# CITY OF ALBUQUERQUE

**Re: McDonald's at Candelaria / Eubank, 9515 Candelaria,  
Traffic Circulation Layout  
No Engineer's Stamp provided (G20-D031)**

**Re: McDonalds, 9515 Candelaria NE**  
**Grading and Drainage Plan**  
**Engineer's Stamp dated 5/3/11 (G20/D031)**

## Narrative of City Comments

L.C. NUMBER: 030-0004 CORPORATE DWG. NAME: **SITE PLAN**

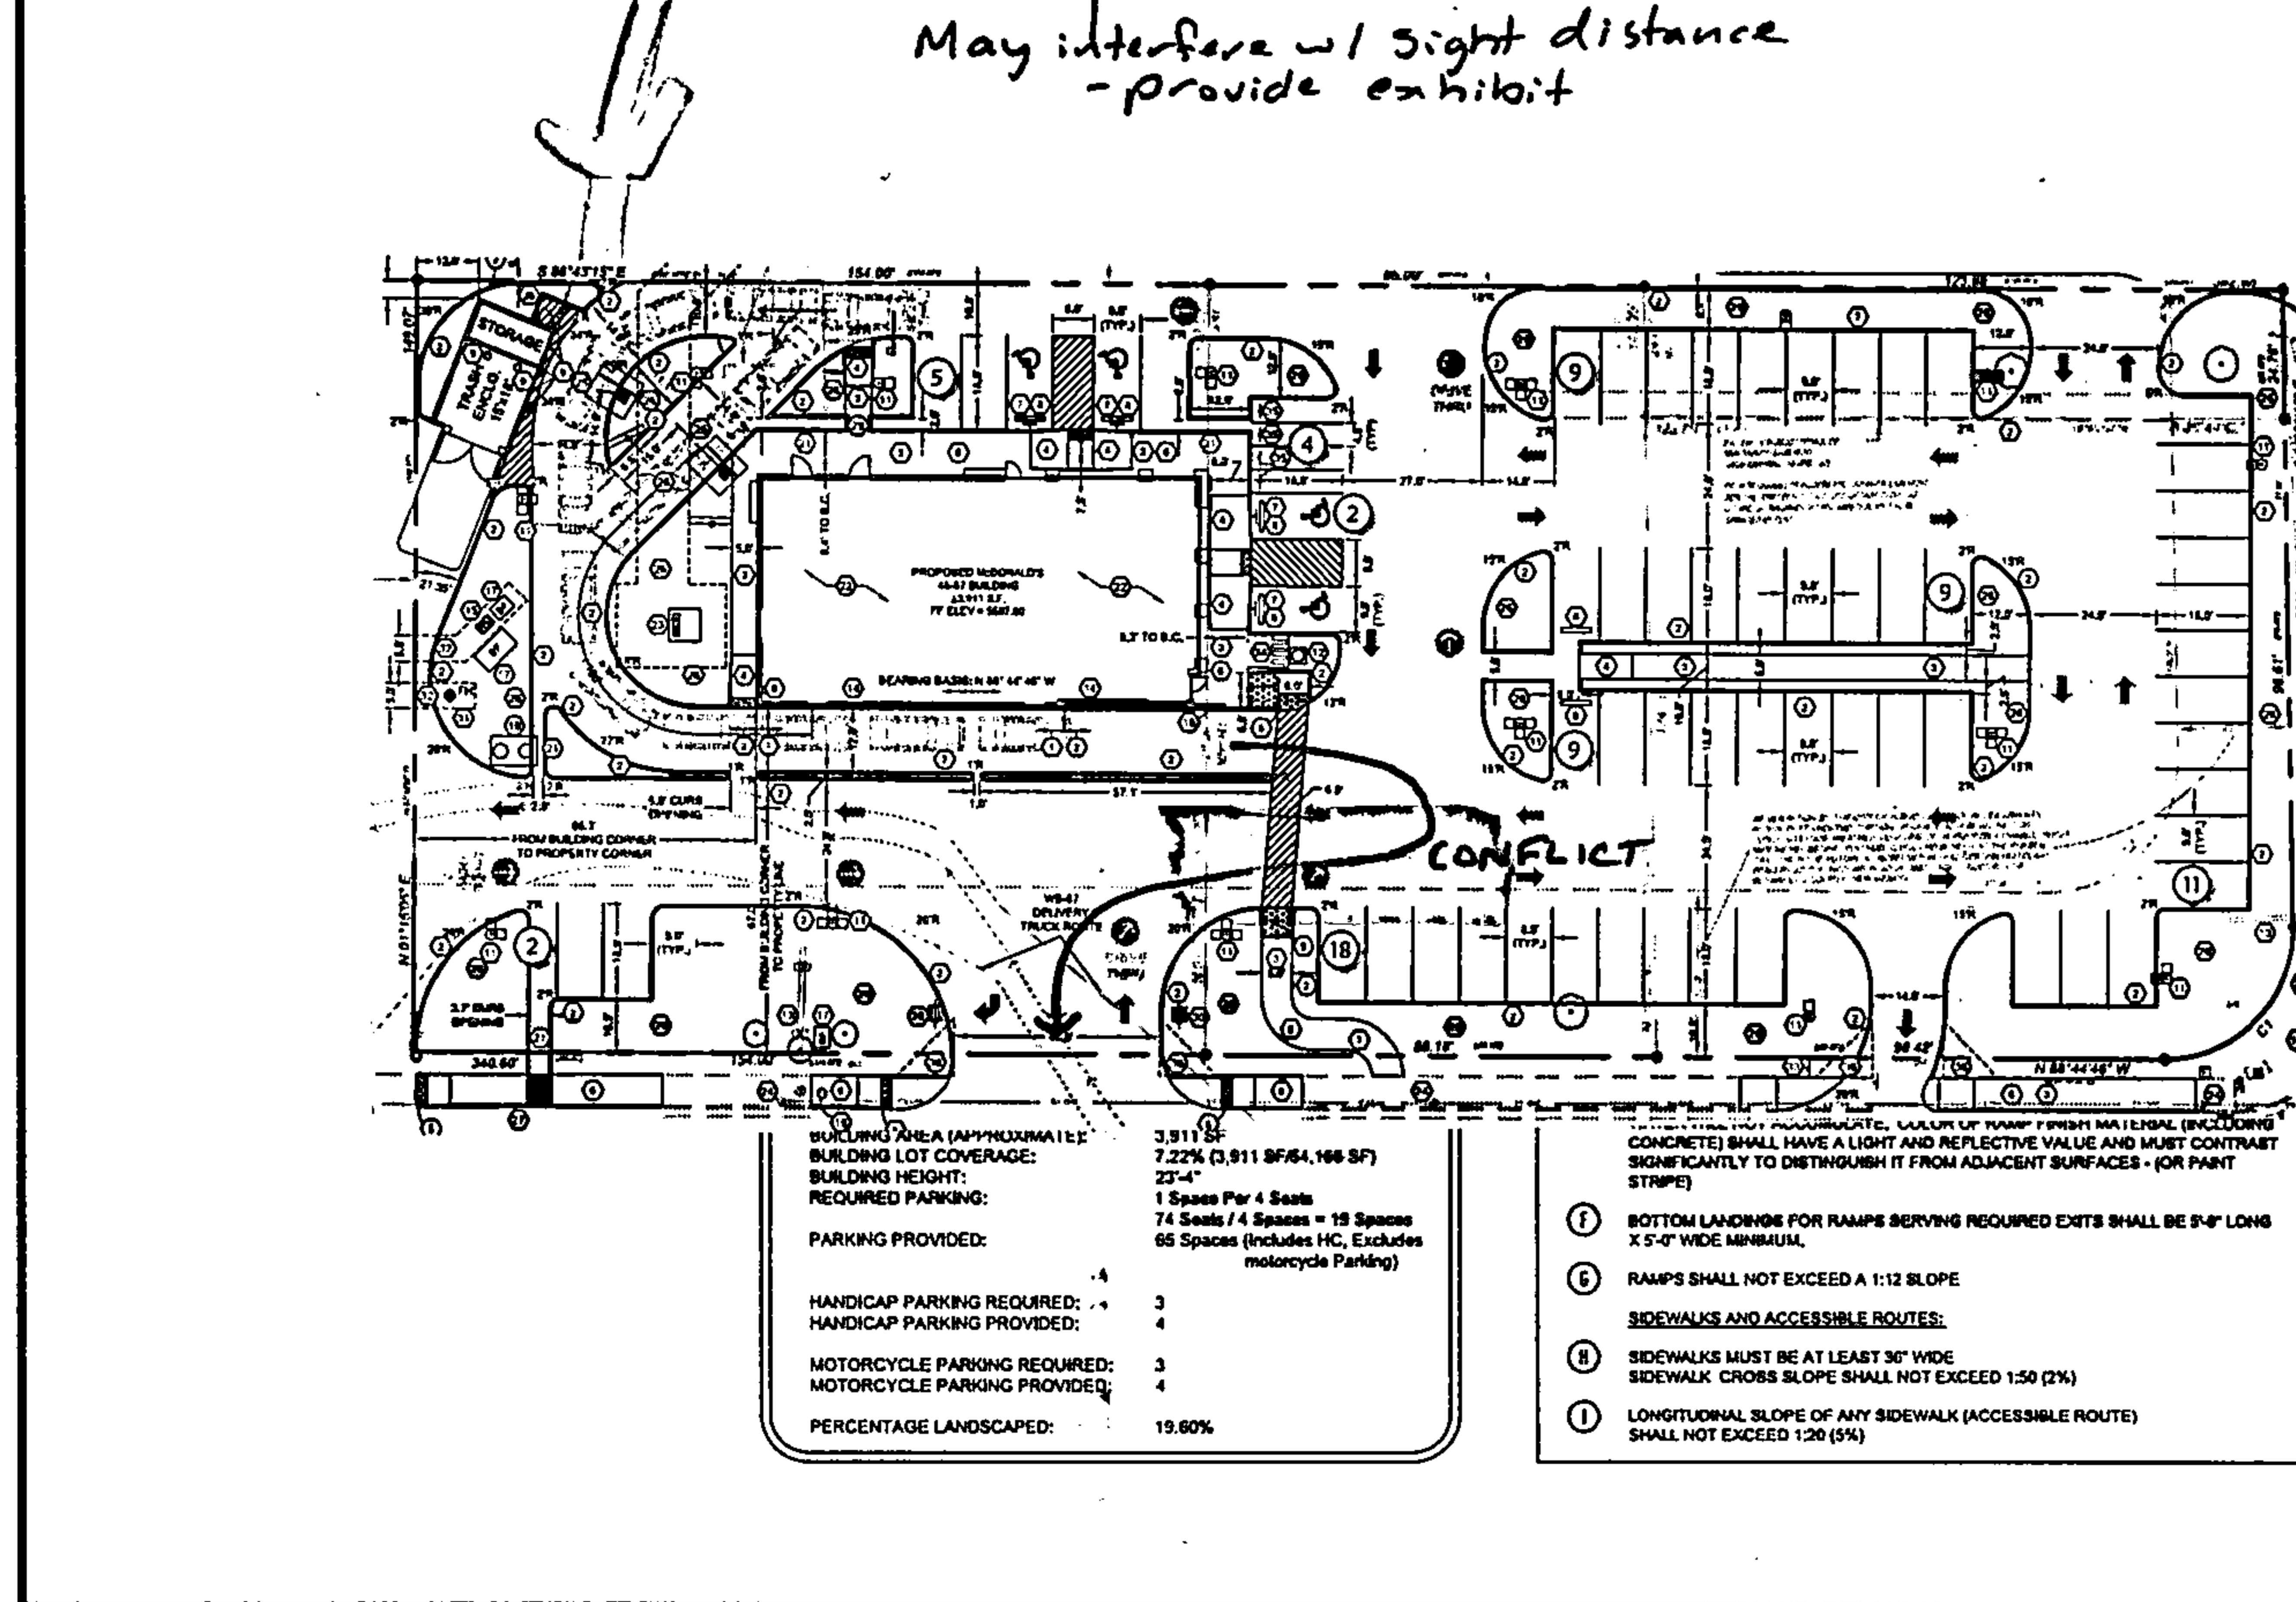
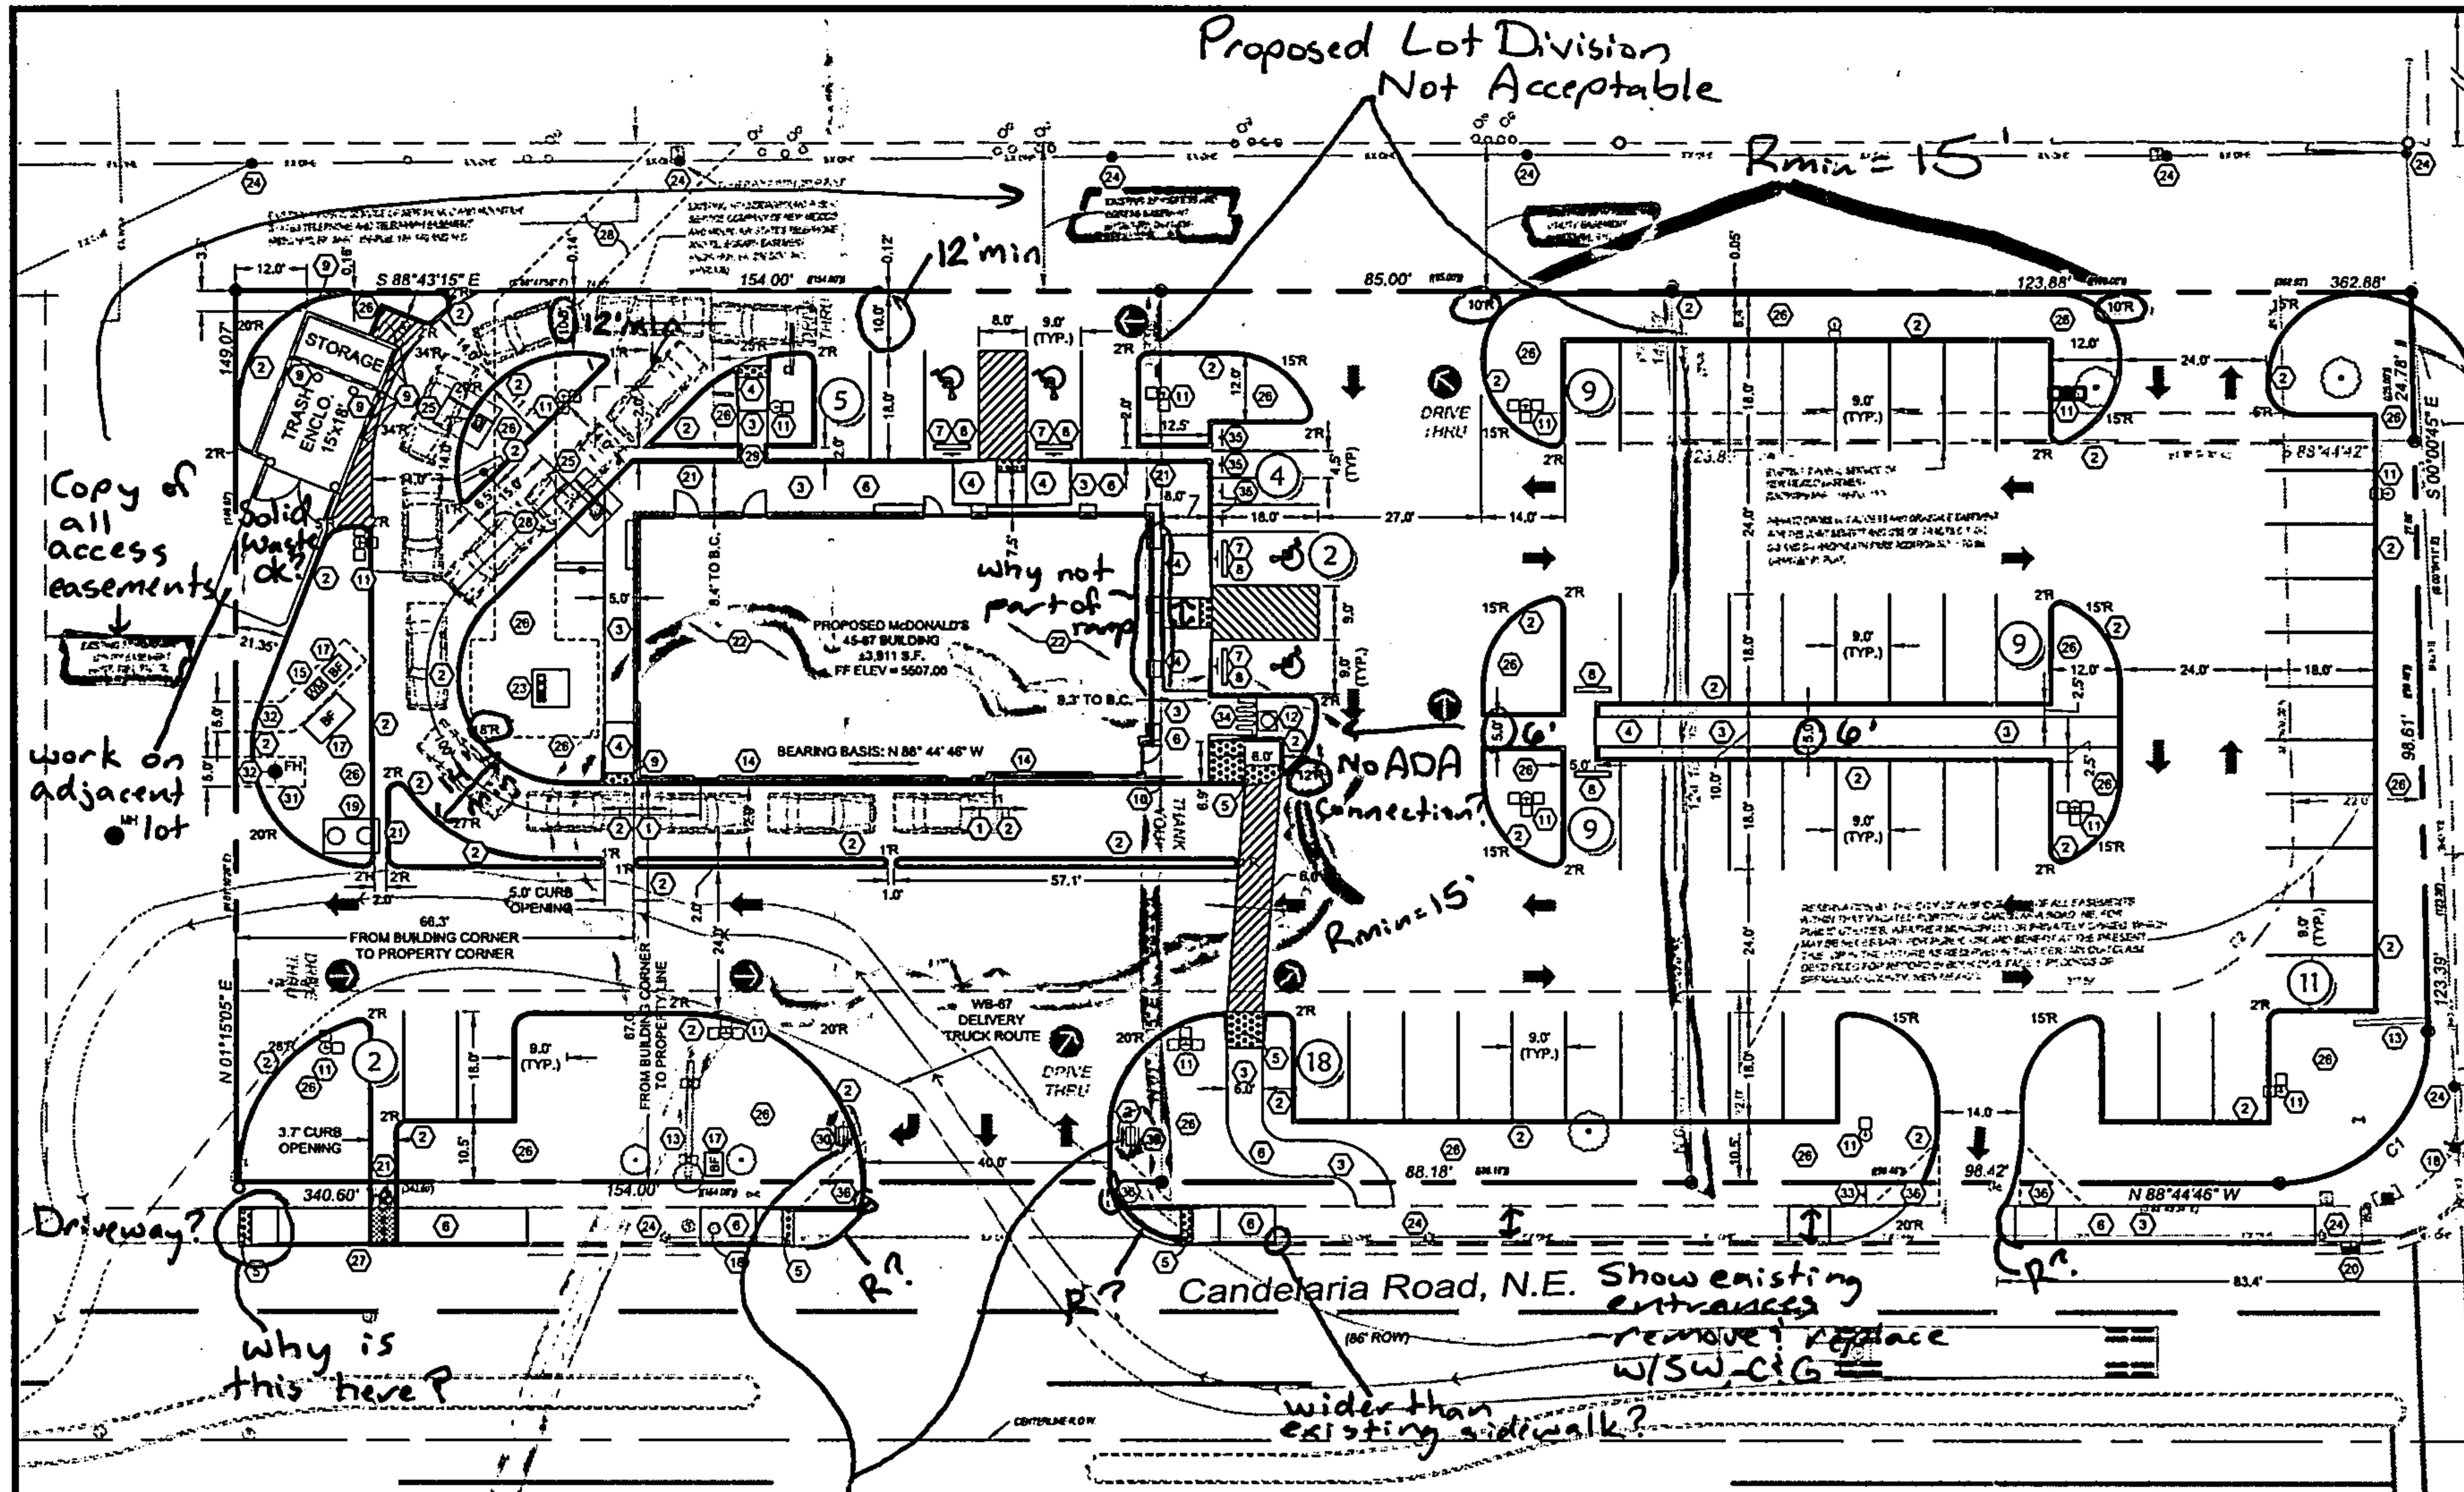
1. The drive through exit introduces a conflict between drivers entering the site and those exiting the drive through who wish to turn left on Candelaria. Please revise.

6. A portion of the entrance off of Eubank is not located within the access easement. An additional easement or modification of the entrance will be required.

7. Provide a copy of all access easements.
8. Clarify existing versus proposed conditions.
9. The plan shows proposed work on the adjacent lots; written permission from the adjacent lot owners must be provided.

10. Please show the location of the nearest driveway on the adjacent lot.
11. Shaded property lines are shown on the plan; is this a proposed replat? The proposed lots appear to be undevelopable; please provide additional information.

12. The proposed directional signage may interfere with the sight distance at the entrances. Please provide a sight distance exhibit for the entrance (See the *Development Process Manual*, Chapter 23, Section 6, Part B.12).

13. Provide a copy of solid waste approval.
14. Ramps should be the same width as the surrounding sidewalk.
15. Adequate throat depths must be maintained off of Candelaria and Eubank. See the *Development Process Manual*, Table 23.7.1

Thank you again for taking the time to go over some of your TCL comments for our site yesterday... Would you mind taking a look at the attached pdfs and let me know if you see any major issues?... I've included our revised Site Plan (TCL) and the survey for the existing site for your reference. Once I get your feedback, I'll resubmit 2 hard copies for your full review.

Please notice the proposed "exit-only, right-out" drive about 83' west of Eubank... McDonald's would really appreciate it if you would allow that drive so Drive-Thru traffic would have a relatively convenient way to exit the site...
